ERRATA
LOWER REDWOOD CREEK FLOODPLAIN AND SALMONID HABITAT RESTORATION
AT THE BANDUCCI SITE
ENVIRONMENTAL ASSESSMENT

PART 1: SUMMARY OF CHANGES

PART 2: CHANGES TO TEXT

Figure 4. Proposed Actions (Revised).

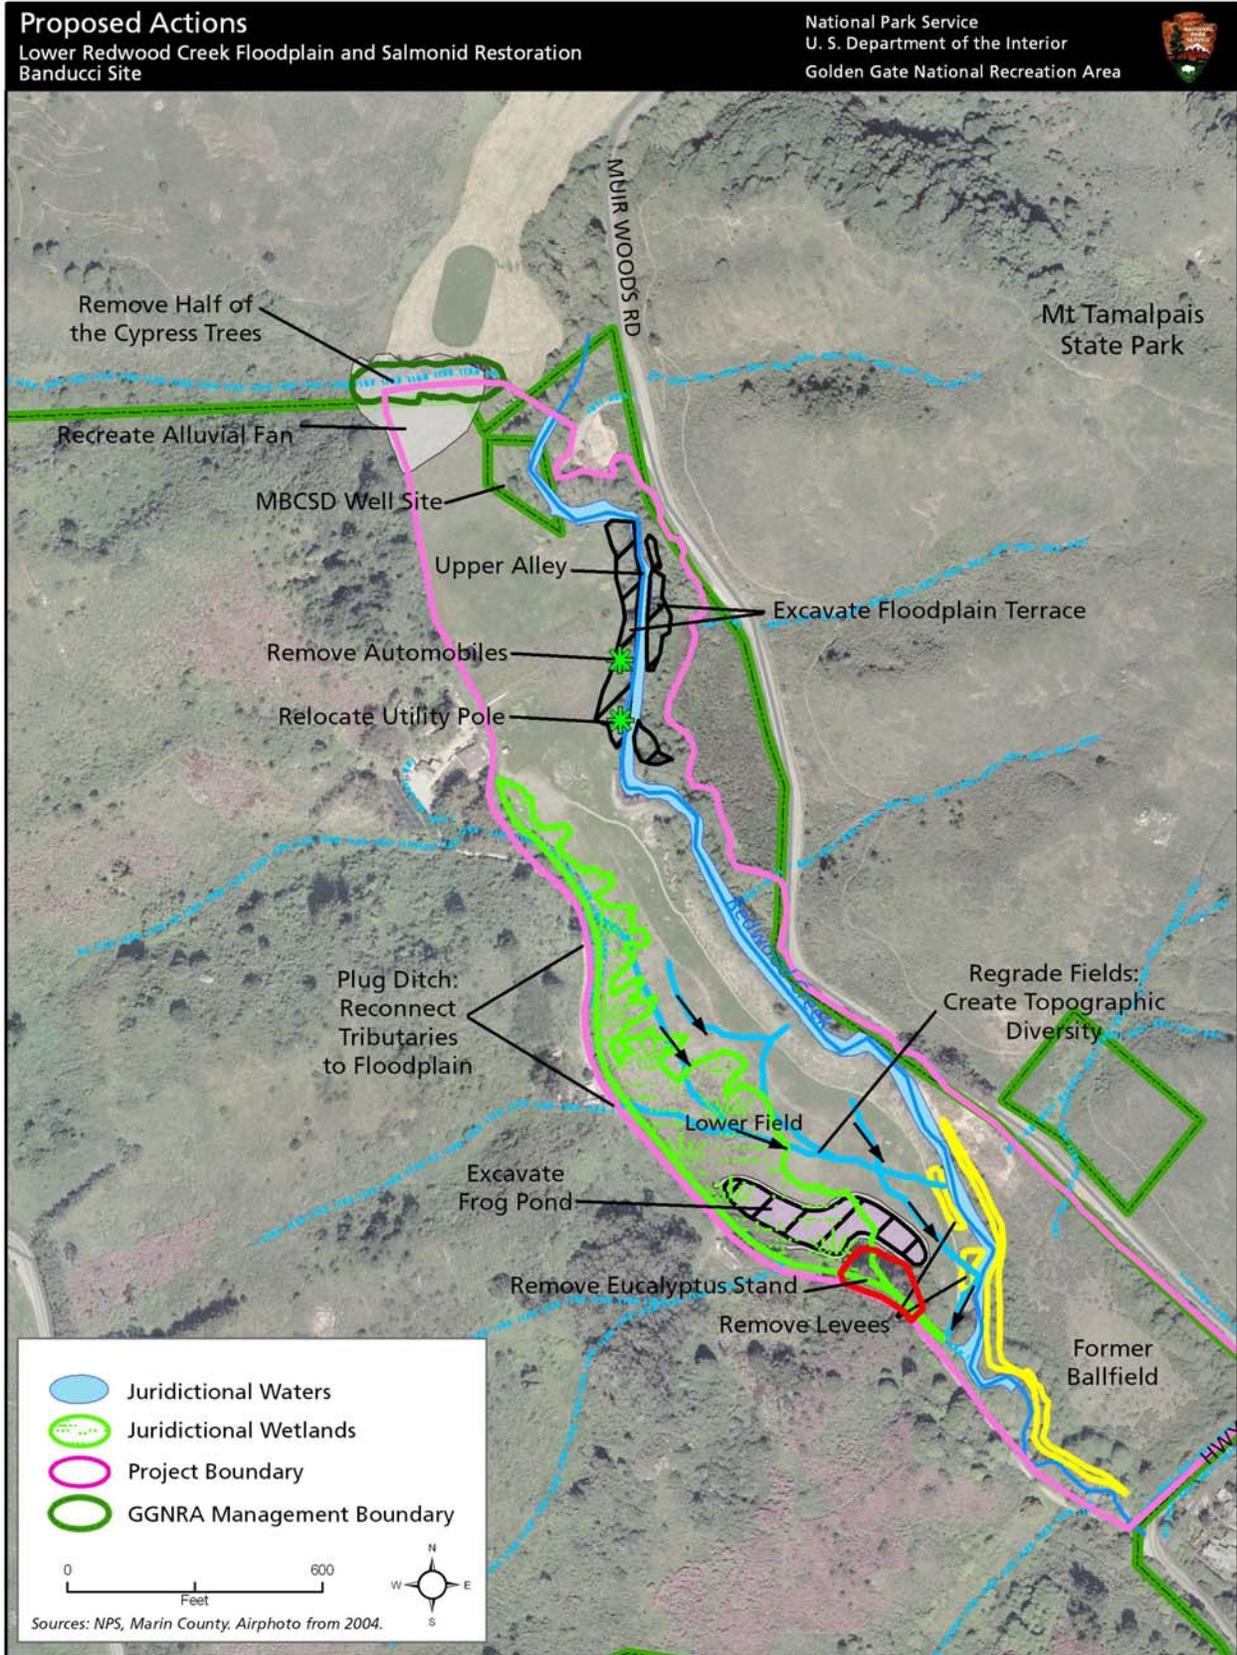
Page 22, Section 2.3, Alternatives Considered in Detail, Alternative 1, Figure 4

Figure 4 is revised as shown on the following page.

Page 32, Section 3.2, Cumulative Impacts, Figure 5

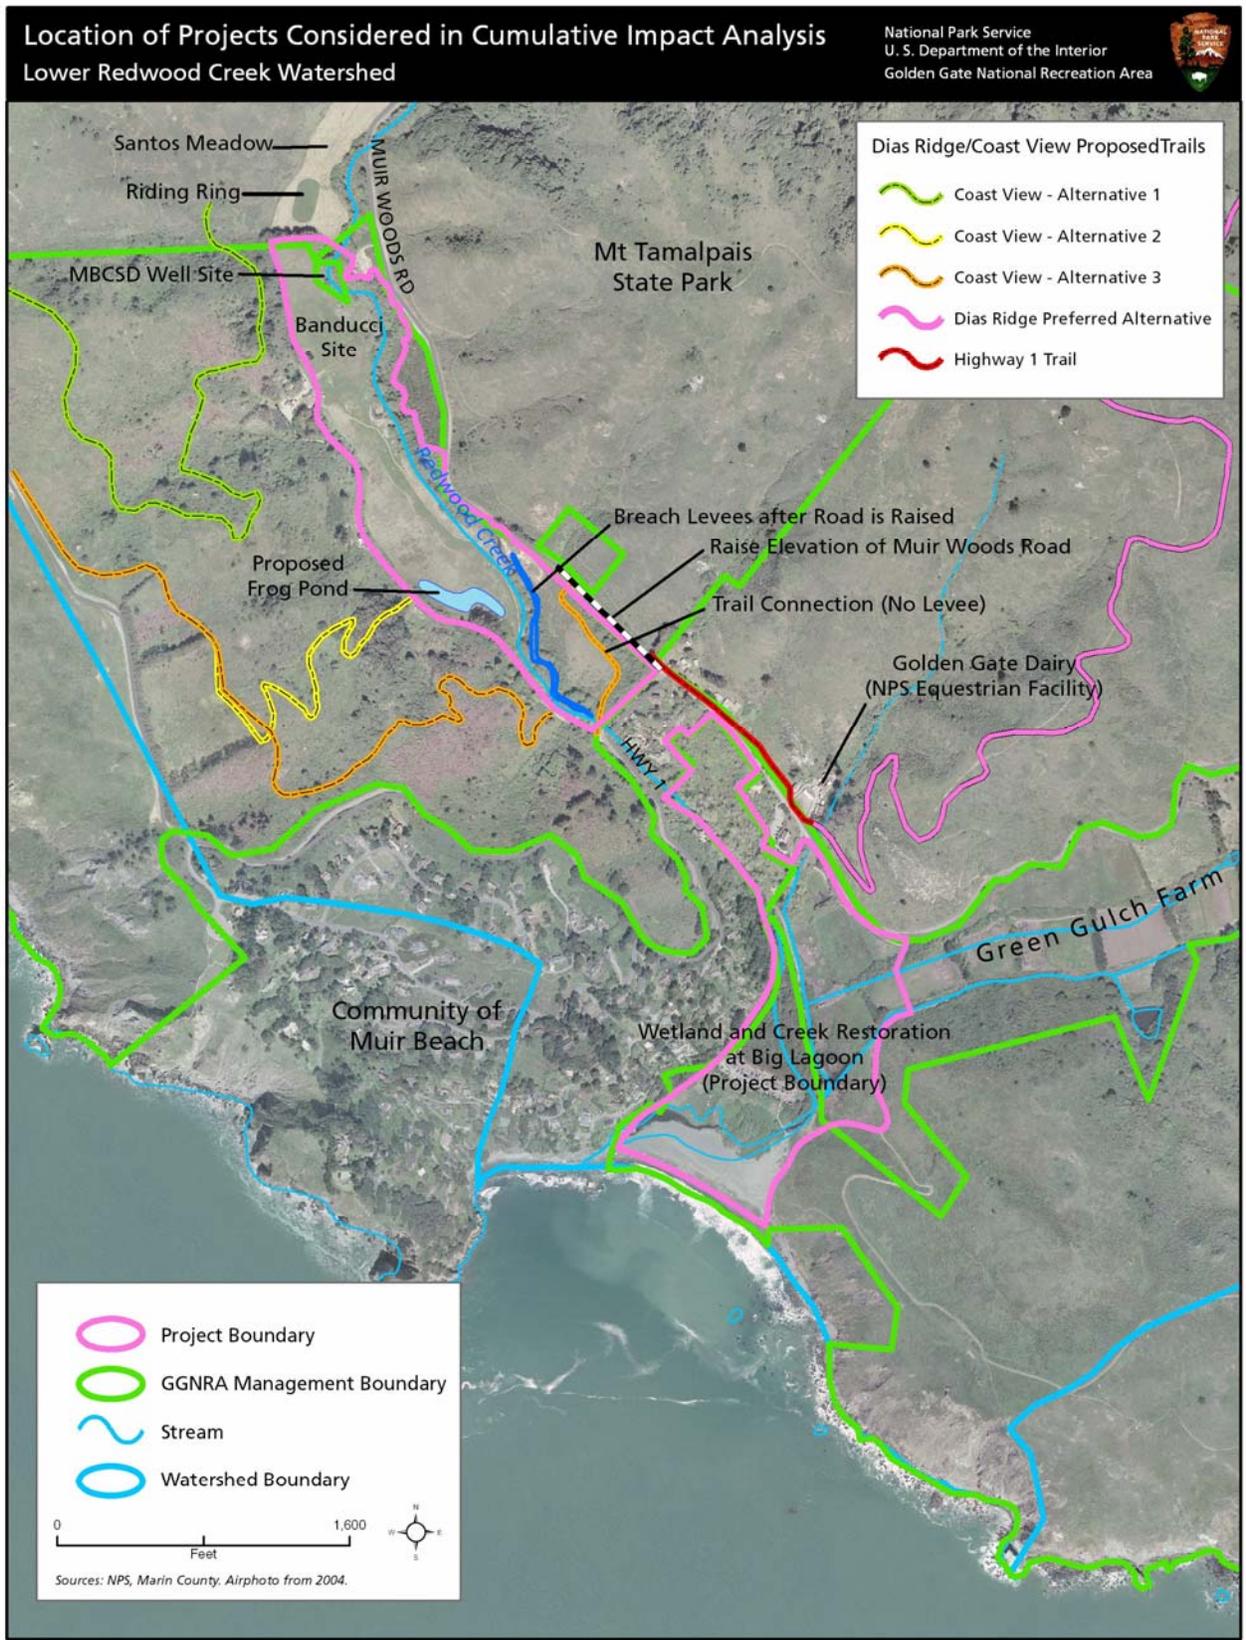
(Figure 5 has been revised: See page 8)
